APPLICATION NO.	FILING DATE	FIRST NAMED INVENTOR	ATTORNEY DOCKET NO.	CONFIRMATION NO.
09/963,577	09/27/2001	Ryoichiro Uehara	05711.0122	9686

Office Action Summary

DETAILED ACTION

【図1】

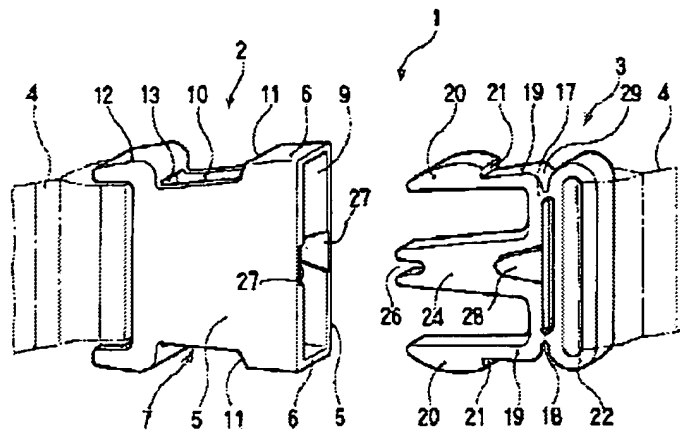
JP 8-131215 (figures 1, 2, 6, 13, 14, 16, 17) teaches a buckle comprising a female body 2 formed with a flat housing and a male body 3 having flexible insertion legs 20 which are engaged with each other by insertion, each of the female body and the male body having a front surface, a rear surface, and right and left side faces, and having butting portion including straight portions 18 and a convex portion 28 formed on the front surface of the male body and a concave portion 27 with straight portions defined by the edge of the mouth of the female body on the inside surface of the front face of the female body 2, wherein the concave 27 and convex 28 portions are formed at a center of the butting portion sandwiched by the straight portions 18 on the male body and the corresponding straight portions of the female body, the convex portion 28 in the butting portions protrudes in a wedge-shaped form with a rounded narrowed leading edge while the concave portion 27 is dented with the inlet expanded, the female and male bodies are thereby formed closely in contact at the butting portions, a guide 24 is protruded linearly from a center of a front end of the convex portion 28 of the male body, and partition pieces 16, 25 for

As to claim 3, JP 8-131215 shows in figure 1 the concave and convex butting surfaces formed on both front and rear surfaces of the male and female bodies.

In regard to claim 4, JP 8-131215 shows in figure 1 the concave and convex butting surfaces sandwiched between straight butting portions formed on both front and rear surfaces of the male and female bodies. Claim 4 requires butting straight or linear-form butting portions on two opposite sides and the convex and concave portions on one side. JP 8-131215 shows this. Claim 4 is silent on prohibiting other butting configurations such as convex and concave on the opposite surface. There are no limitations in claim 4 to prohibit convex and concave portions on both sides.

As to claim 12, the side view shown in figure 1 shows the convex portion and straight portions being notched to a one level lower stepped portion which fits into the female body so as to be overlapped thereby.

【図14】

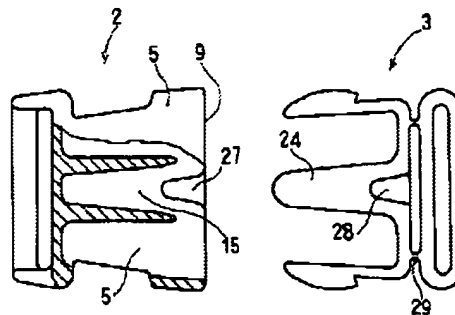
As to claim 7, JP 8-131215 shows the concave portion of the female body and the convex portion on the male body in figures 1, 13, 14, 16, and 17.

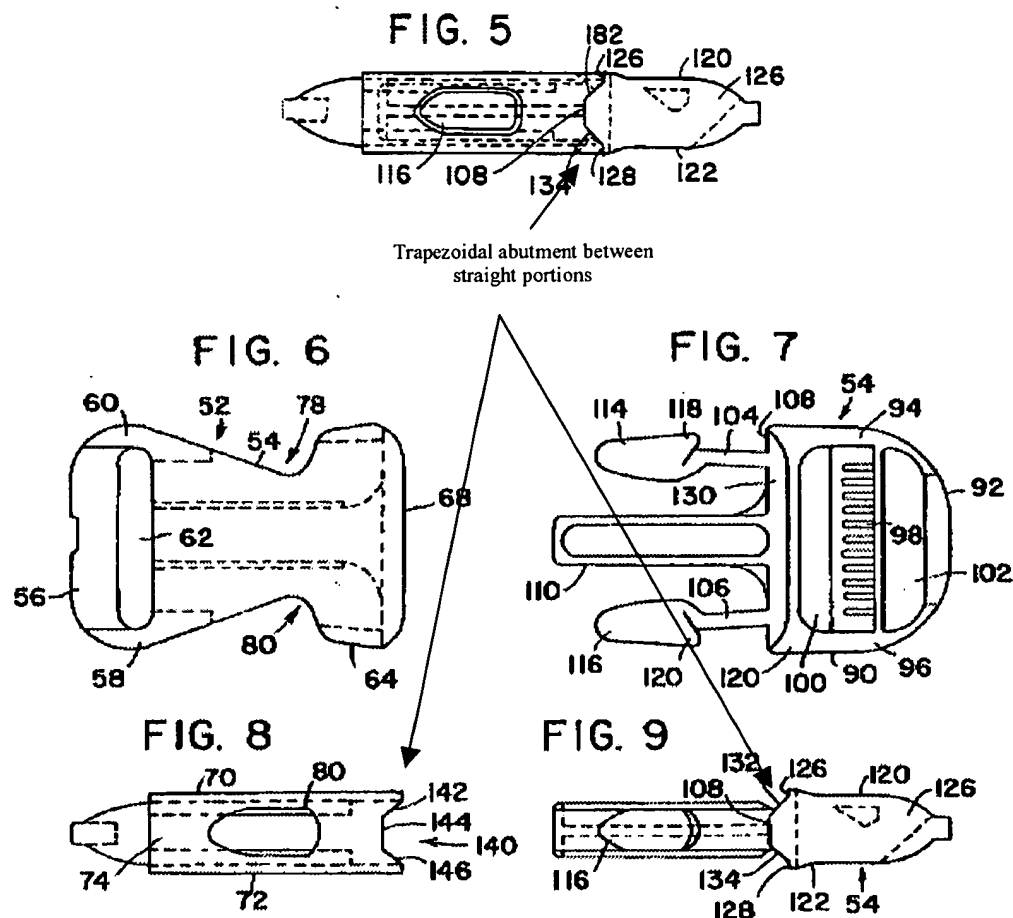
The difference is that the convex portion is not trapezoidal and the concave portion does not extend through the thickness of the front face of the female body so as to exist on the front surface. However, Krauss (figures 5-9) teaches a buckle similar to JP 8-131215 and further suggests the use of a trapezoidal butting guide 132, 134, 108 positioned on opposite side faces of the male body fitting into a cooperating recesses 142, 144, 146 on side faces of the opening of the female body that extend completely through the side faces so as to provide a geometry well known in buckles to provide stable interengagement between the male and female bodies.
